MANUFACTURERS' RECEIVER TROUBLE CURES

VOLUME 4

A RIDER Publication

Fig. 1 — Philharmonic

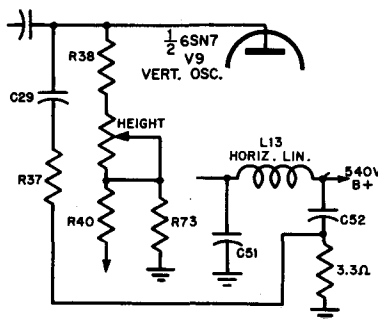
1. Place a 3.3-ohm resistor in series with C52 (.05 μ f) to ground. This capacitor, shown in the figure,

is connected to one side of the linearity coil.

Fig. 2 — Philharmonic

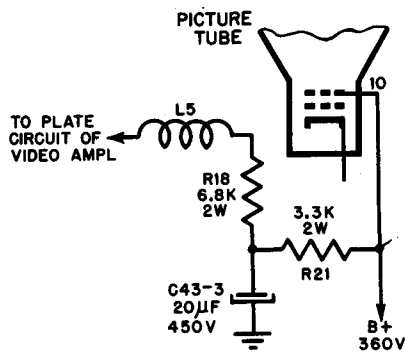
If the set is going to be operated under conditions of low line voltages (less than 105 volts), make the following changes:

1. Remove C58, .02- μ f, 1,000-volt capacitor connected between pin 10 of the picture tube and ground.

2. Remove R76, 10-k resistor connected to pin 10 of the picture tube.

Fig. 3 - Pilot

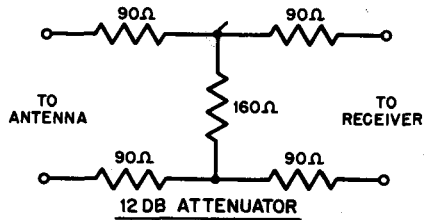
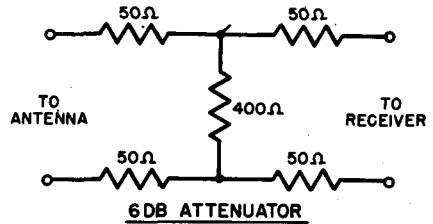
In strong-signal areas, excessive input at the antenna terminals will produce picture smear and picture jitter. This is due to cross-modulation effects in the r-f amplifier which

may operate as a detector on the nonlinear portion of its curve near cut-off. An attenuation network at the antenna terminals will remedy this condition. A 6-db and a 12-db attenuator network are shown in the figure.

Fig. 5 - RCA Victor

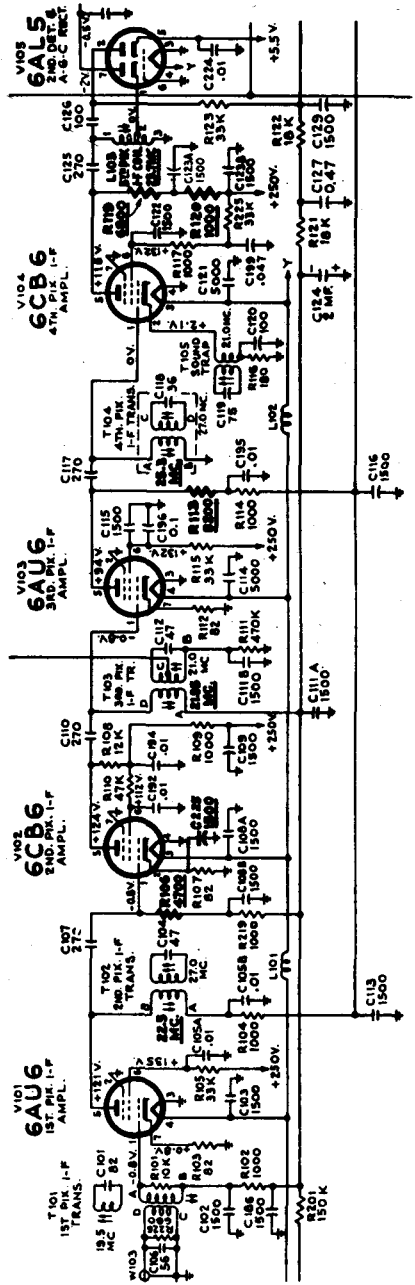
In those fringe areas where additional sound gain is desirable, the

following suggestion will effect up to a 4 to 1 increase in sound gain. See the figure for a partial schematic diagram showing the changes for model 7T103.

1. Change the second picture i-f grid resistor (*R106* in 17- and 19-inch models, *R107* in 14-inch models) from 8,200 to 4,700 ohms.

2. Change the third picture i-f plate-load resistor (*R113* in 17- and 19-inch models, *R115* in 14-inch models) from 1,800 to 8,200 ohms.

3. Change the fourth picture i-f plate-isolating resistor (*R120* in all models) from 6,800 to 1,000 ohms.

4. Remove the fourth picture i-f plate-load resistor and peaking coil (*R119* and *L114* in all models). In some cases, *L114* is wound on *R119*.

6. Add a 1,500- μ f ceramic capacitor across the second picture i-f cathode resistor (pin 2 of *V102* to ground). Use the shortest possible leads.

Increasing sync stability in low-signal, high-noise areas

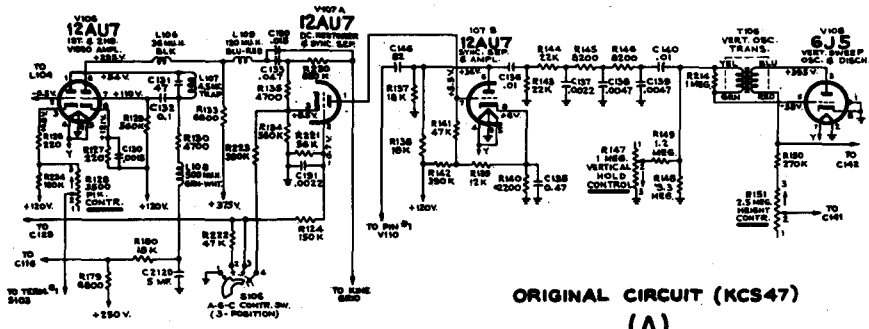
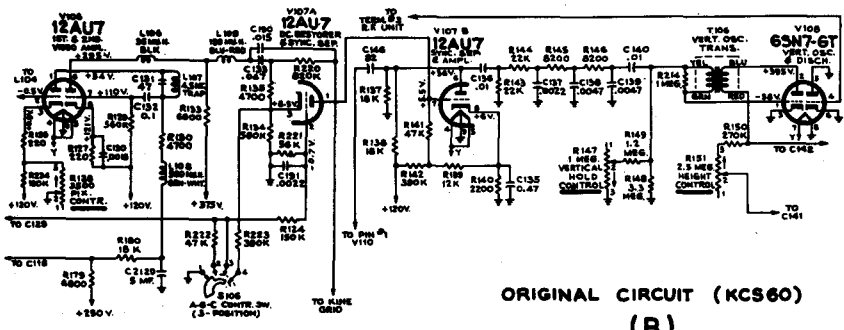
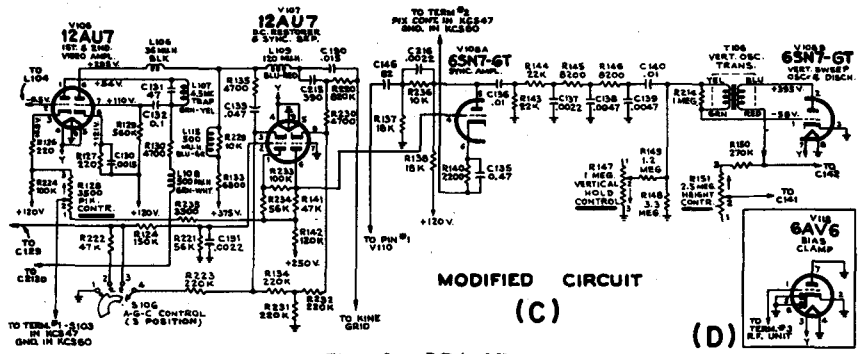
Part (A) of the figure shows the conventional 16-inch and 19-inch table model and console (chassis KCS47) sync separator, d-c restorer, sync amplifier and vertical-oscillator circuits. Part (B) of the figure shows the schematic of the same circuits of the 16-inch and 19-inch combination instruments (chassis KCS60).

Part (C) of the figure shows the modified sync, d-c restorer, and vertical-oscillator circuits, which are the same for both straight television instruments and combinations. When these modifications are made, the sync stability is increased in low-signal strength, high-noise areas.

tion of the 6SN7 tube V108 which was formerly used as a bias-clamp is reconnected as a sync amplifier, and it is necessary to install a separate bias-clamp tube. The connections for the additional bias-clamp are shown in part (D) of the figure. Although type 6AV6 is recommend-

Fig. 7 — RCA Victor

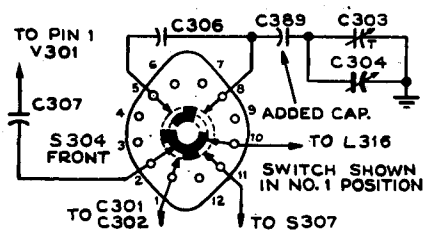
A .05- μ f capacitor, designated C389 was added between terminal 8 of function switch S304 (front) and tuning capacitor C303/C304 in radio chassis RC617A.

Early production models of the receiver will not have this capacitor in the radio chassis.

When the radio-function switch is in the TV position, the filament voltage is present on the high side of the tuning capacitor (C303/C304) due to the function switch design. Any shorting of the tuning capacitors to ground causes L314 (filament choke) to burn out. The insertion of the capacitor removes filament voltage from the tuning capacitor without affecting its operation.

Fig. 8 — RCA Victor

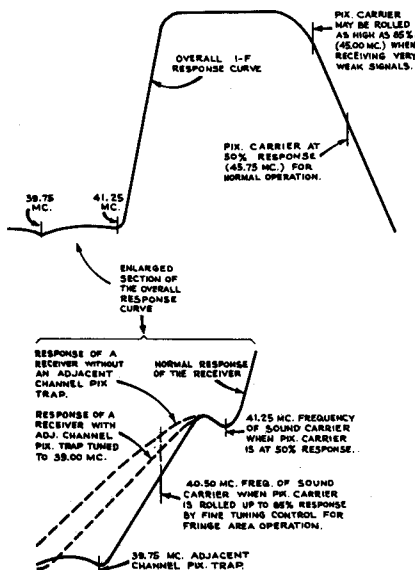
it is common practice to adjust the fine-tuning control so as to move the picture carrier up the slope to improve the signal-to-noise ratio. The actual amount that the carrier is moved depends upon the signal strength. On extremely weak signals, the picture carrier may be moved as high as 80 to 90 percent on the slope of the curve. This may represent a change of as much as 75 megacycles of all frequencies being passed through the picture i-f amplifier. Under such conditions the sound may become weak and noisy even on intercarrier receivers. The reason for this is shown in the figure.

When the picture carrier is rolled up the slope and lowered in frequency by .75 mc, the sound carrier is also lowered in frequency by .75 mc to become 40.50 mc. As can be seen by the enlarged section of the response curve, the sound carrier begins to fall into the adjacent channel picture trap with a consequent reduction of sound output. Receiver designs which do not incorporate an adjacent channel picture trap may avoid this difficulty at the expense of adjacent channel picture rejection.

It is possible to overcome the above described difficulty in many cases by a simple adjustment which can be made in the field without the aid of test equipment. When the picture carrier is rolled up the slope by .75 mc, the adjacent channel picture carrier is lowered in frequency to 39.00 mc and no longer falls into the adjacent channel picture trap. If the trap is returned to 39.00 mc, it will permit the response at 40.50 mc to rise somewhat, produce stronger sound, and will produce greater adjacent channel picture rejection un-

der the actual operating condition. If a strong signal is available on another channel and the fine tuning is adjusted to roll the picture carrier down the slope to the normal 50-percent point, the adjacent channel picture trap will appear mistuned. However, it is not likely that adjacent channel picture interference will be experienced on strong signals.

Fig. 9 — RCA Victor

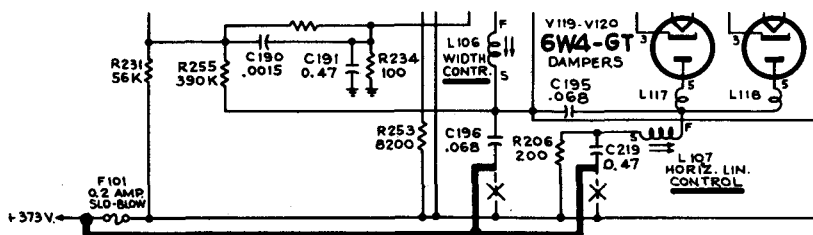
In a few 21-inch receivers, the slow-blow fuse has been known to fail due to a-c from the sweep circuit flowing through *F101*. To elim-

inate this difficulty the factory has made a wiring change. *C196* (.068 μf) and *C219* (.047 μf) were changed from their original connection and reconnected to the +373 volt bus side of the fuse as shown in the partial schematic diagram.

As a field-service convenience, if a slow-blow type fuse fails in an unmodified 21-inch receiver, it should be replaced by a quick-blow type (stock No. 73600). However, if an unmodified receiver is brought into the shop for service, *C196* and *C219* should be reconnected and a slow-blow fuse installed.

Fig. 10 — RCA Victor

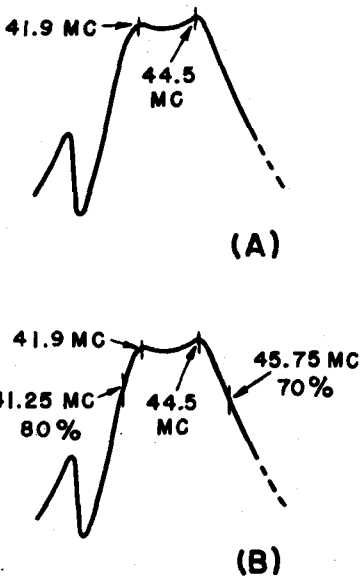
It has been found desirable to align *T1* (converter transformer) and *T104* (1st picture i-f grid transformer) to the response shown in part (B) of the figure rather than as it appears in the service data (see part A).

Fig. 11 — RCA Victor

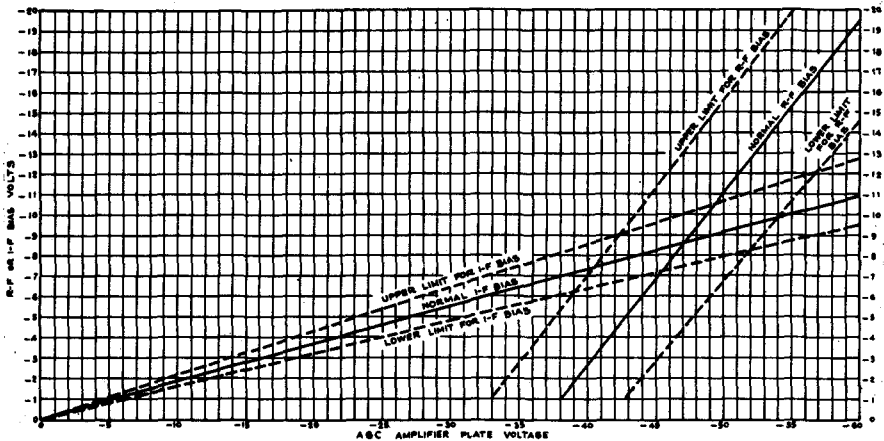
In medium field strength areas an occasional receiver may show some snow on signals in the 300 to 1,000 microvolt signal range due to an improper ratio of r-f and i-f bias. If the r-f bias is high with respect to the i-f bias, the picture becomes snowy. If the i-f bias is too high with respect to r-f bias, the receiver may overload on strong signals.

To determine whether or not the biases are of the correct ratio, tune in a signal and measure the r-f bias, the i-f bias, and the agc amplifier plate voltage with a VTVM. The signal must be steady during these measurements. Plot these points on the accompanying graph. The values should fall within the range of the dotted lines.

According to the graph, when the agc amplifier plate measures -45 volts, the i-f bias should be -8.2 volts. If the i-f bias actually measured -10 volts, it indicates that *R143* (68-k resistor in i-f agc bus) or *R145* (150-k resistor connected to plate of agc amplifier) is too low

in value and/or $R144$ or $R150$ (82-k and 150-k resistors connected to ground in the i-f agc bus) is too high. If, however, the i-f bias actually measured —6 volts, it indicates $R143$ or $R145$ is too high in value and/or $R144$ or $R150$ is too low. The resistors originally employed in production were 10 percent tolerance units. However, if $R143$ and $R145$ are at one limit of their tolerance and $R144$ and $R150$ are at the other limit of their tolerance, a considerable error in i-f bias is produced.

Fig. 12 — RCA Victor

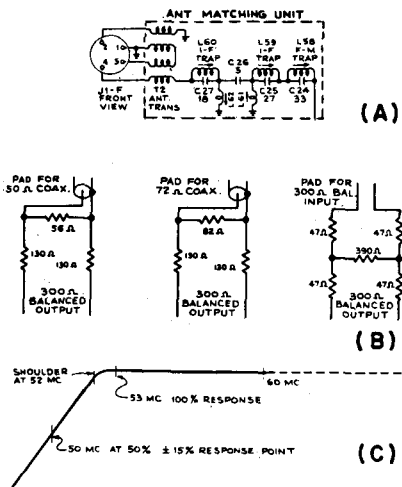
Alignment of antenna-matching unit with low-output signal generator (see Fig. 12).

16. Adjust *L61* and *L62* (see part A of figure) to obtain the response shown in part (C) of the illustration. *L61* is most effective in locating the position of the shoulder of the curve at 52 mc, and *L62* should be adjusted to give maximum amplitude at 53 mc and above, consistent with the specified shape of the response curve. The adjustments in the matching unit interact to some extent. Repeat the above procedure until no further adjustments are necessary.

Fig. 13 — RCA Victor

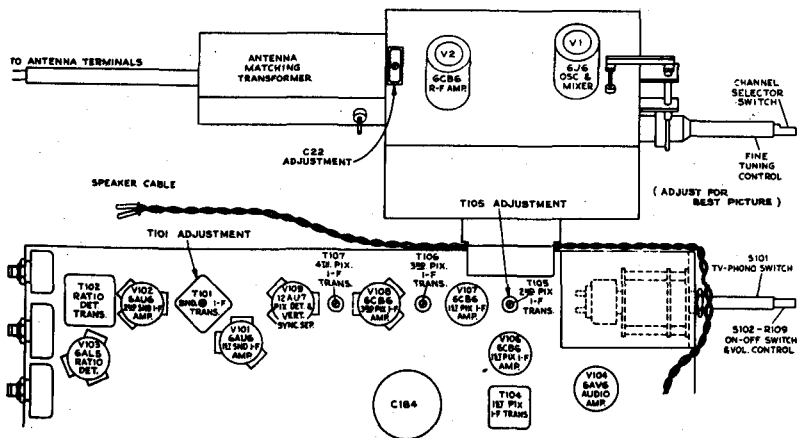
In setting the agc control on these receivers, care must be taken that the receiver is generating the maximum agc voltage which will be required for that particular location of the receiver. If the agc control is adjusted on a weak signal, the receiver may overload, bend on sync, etc., when a stronger signal is received.

The correct agc adjustment, explained in equipment service notes, is important in obtaining the best performance from the receiver. Adequate picture contrast may also be difficult to obtain if the agc control is not properly adjusted, inasmuch as the agc control setting determines the i-f signal voltage level appearing at the picture second detector. In medium- and strong-signal areas, this adjustment should be made on the strongest signal to avoid receiver overload. In weak-signal areas, the maximum clockwise adjustment which gives best signal-to-noise ratio (minimum snow) may be preferred.

One source of difficulty not likely to be suspected is the position of the fine-tuning control. If the agc control is adjusted with the fine tuning set so that the picture carrier is low on the slope of the i-f response curve, then the receiver may overload or bend on sync when the picture carrier is moved up the slope with the fine-tuning control. The obvious cure is to set fine tuning so that the picture carrier is well up the slope (fine tuning counterclockwise on KRK8) when making final adjustment of the agc control.

Fig. 14 — RCA Victor

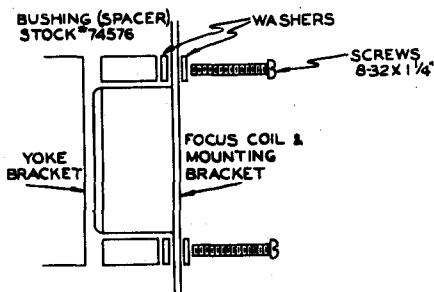
If it is impossible to remove picture-tube shadows by the prescribed method (see service notes) of adjusting the focus coil and ion-trap magnet, then make the following test:

1. Remove the two focus coil mounting screws (8-32 x $\frac{3}{8}$ ") and reverse the focus coil. Temporarily replace it in a position adjacent to the deflection yoke.

If the above test indicates that the focus coil in a reversed position is the desired position, then the mounting modification shown in the figure is recommended. The materials required for the focus coil mounting modification are given in the figure.

Fig. 16 - RCA Victor

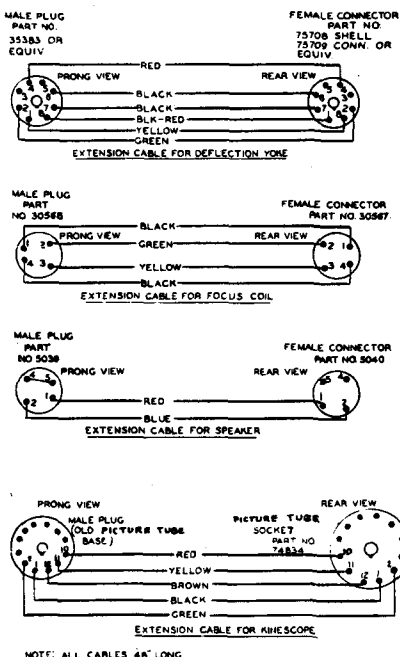
The yoke, focus coil, and picture tube are fastened to the cabinet in the above series receivers and not to the chassis as in all previous models.

When the chassis is removed from the cabinet for service, it will be necessary to unplug the yoke and focus coil. With either of these two components out of the circuit, the receiver cannot be operated because of the +B disconnect incorporated in each plug.

The figure describes how these extension cables can be made, also stock numbers of plugs and connectors used.

Fig. 18 — RCA Victor

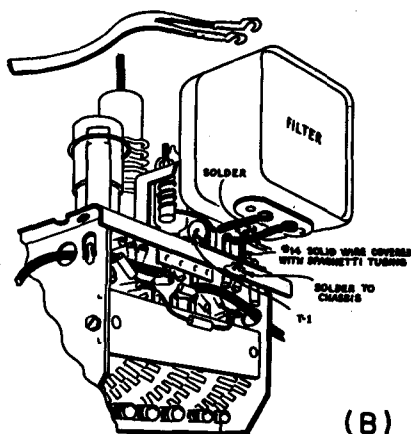
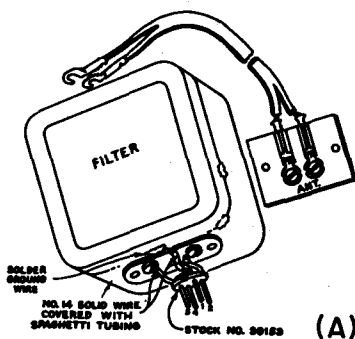
Part (A) of the figure shows the method of attaching the antenna input connectors to the filter so that

it can be plugged directly into the antenna matching units employed with KRK5, KRK7, and KRK8 r-f tuners.

Part (B) of the figure shows the method of mounting the filter on receivers employing KRK2 r-f units.

Fig. 20 — RCA Victor

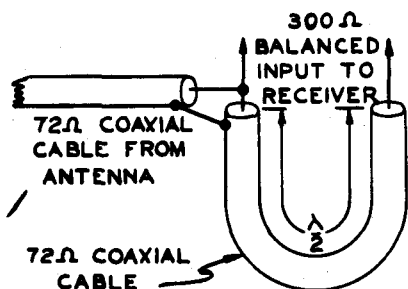
**Coax to balanced line
matching network**
(see Fig. 20).

In some locations it may be necessary to use 72-ohm coax transmission line between antenna and receiver because of reflection or interference pick-up. Later receivers are provided with a 72-ohm coax input in addition to the usual 300-ohm input. Early receivers employing the above series r-f tuner units are provided only with 300-ohm balanced input. To connect the coax to these early receivers, construct a network as shown in the figure. The matching section should be one electrical half wavelength long for the picture carrier of the weakest signal received.

Fig. 23 — RCA Victor

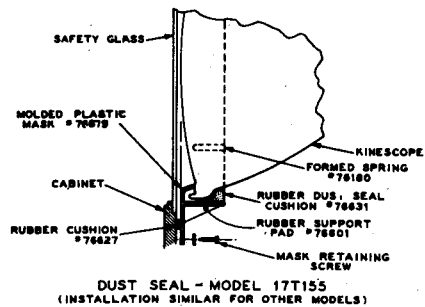
To install the dust seal, proceed as follows:

1. Apply cement (see note below) around entire periphery of both the picture tube and the mask surfaces which are in contact with the dust seal. Caution: Do not apply cement to the high-voltage clip. The spring-mounting clips should be pushed securely in place so that they do not protrude beyond the mask flange.

Fig. 24 — RCA Victor

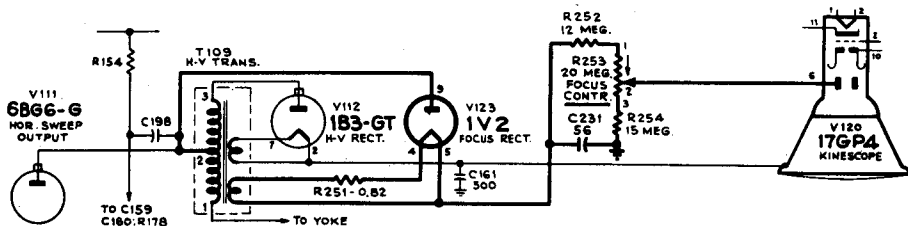
Since the focus magnet is dispensed with on the 17GP4, a new centering magnet is provided to center the picture on the screen. This magnet assembly is in the form of two wire rings mounted on a non-magnetic form which is placed around the neck of the picture tube, and at a distance of about three-eighths of an inch in back of the deflection yoke. When the magnets are rotated on the tube so that the gaps in the rings are together, then maximum picture shifting effect is produced. When the rings are rotated so that their gaps are 180 degrees apart, then little or no shifting of the picture is obtained. To shift the picture, rotate one of the magnets with respect to the other. To move the picture in a desired direction, rotate the entire centering mag-

net assembly around the neck of the picture tube. Repeat these two adjustments until the picture is properly centered and no corner shadows are obtained.

Fig. 26 — Sears Roebuck

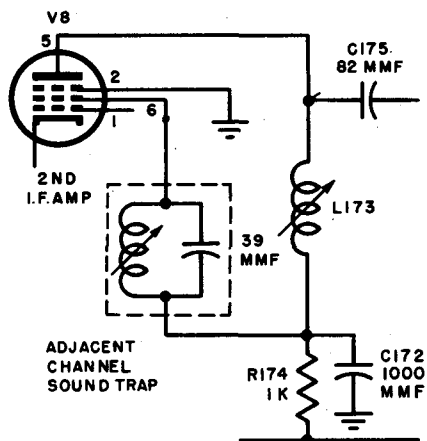
4. Disconnect the second intermediate-frequency coil *L173* from pin 6 of tube *V8* (6AU6).

5. Connect one terminal of the trap coil directly to pin 6 of tube *V8* (6AU6).

Fig. 27 — Sears Roebuck

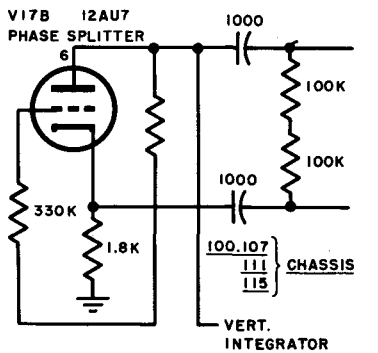
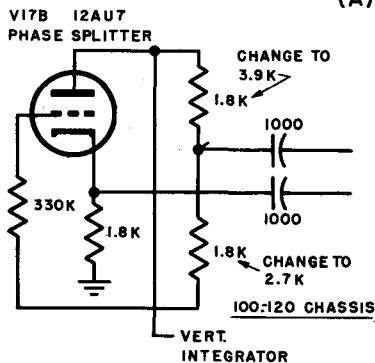
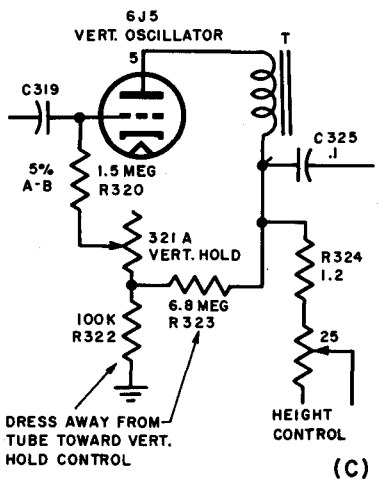
The first circuit (part A) applies to the 100.107, -.111 and -.115 chassis numbers. This circuit was changed in the 100.120 chassis (part B) for better vertical and horizontal stability and improved noise immunity. The arrangement can be incorporated in any of the early sets if complaints are received.

For further improvement in this circuit and to minimize vertical drift, the following changes may be made in low-signal areas. Change the 1.8-k resistor *R351*, closest to the plate of the phase splitter, to 3.9 k, and the lower 1.8-k resistor *R246* to

Fig. 28 — Sears Roebuck

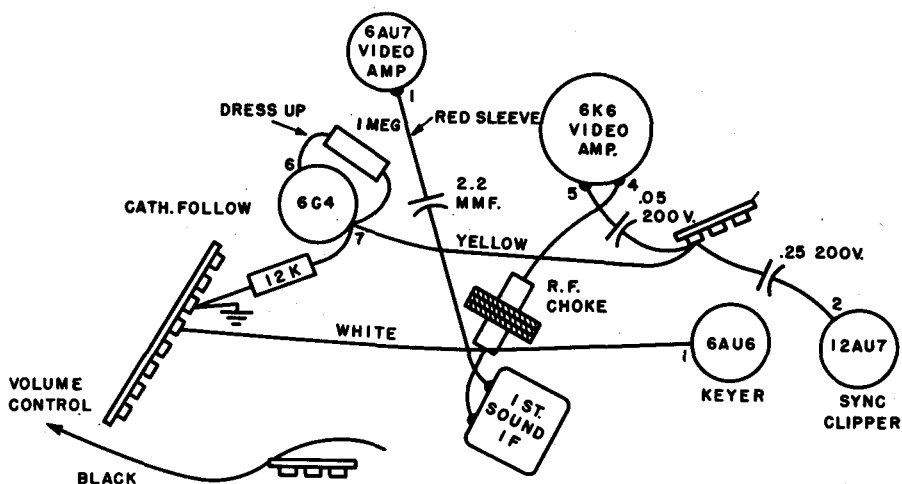
This buzz can be eliminated through careful lead dress of the offending parts. In particular, the yellow lead to the cathode of the keyer tube and the white wire to the grid of the same tube. Both leads are

heavy radiators of radio frequency. By locating a radio-frequency choke between these paralleled leads and the 2.2- μf red-sleeved capacitor, the buzz is reduced to a minimum.

Fig. 30 - Sears Roebuck

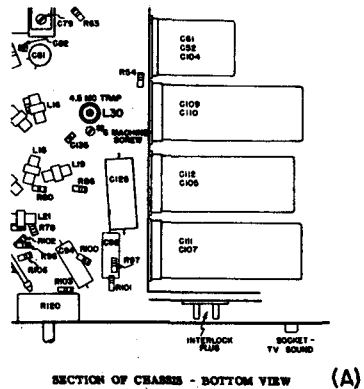
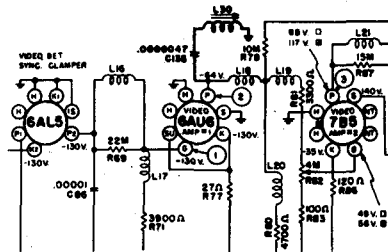
For an undetermined period of time, the above models were produced with less than normal sensitivity. This was due to the fact that the alignment and checking equipment of the manufacturer had drifted and the drifting was unnoticed. The drifting caused a slight misalignment of all chassis affected. The result of the misalignment is a reduction of the sensitivity of the receiver by a sufficient amount to cause complaint in fringe areas.

Complete realignment of the receiver concerned is not recommended since it is not necessary. To restore these receivers to 100 percent performance, a slight retouching of the i-f trimmers on both the video and sound channels using the recommended test equipment is all that is necessary. Inasmuch as the bandwidth was not affected by the drifting of the factory's alignment equipment, this misalignment is not det-

Fig. 33 — Sears Roebuck

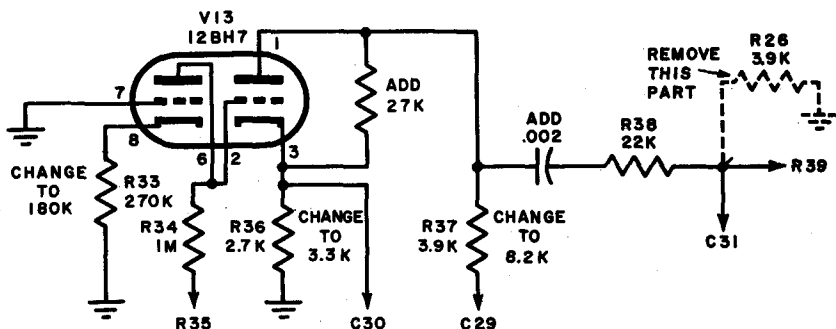
In fringe areas where the above chassis is more critical vertically and more susceptible to noise pulses, it is possible by making a few minor component changes to improve the noise immunity and vertical stability. The changes should be made as follows (see the figure):

1. Add a 27-k resistor from plate (pin 1) of *V13*, 12BH7, to the cathode (pin 3).
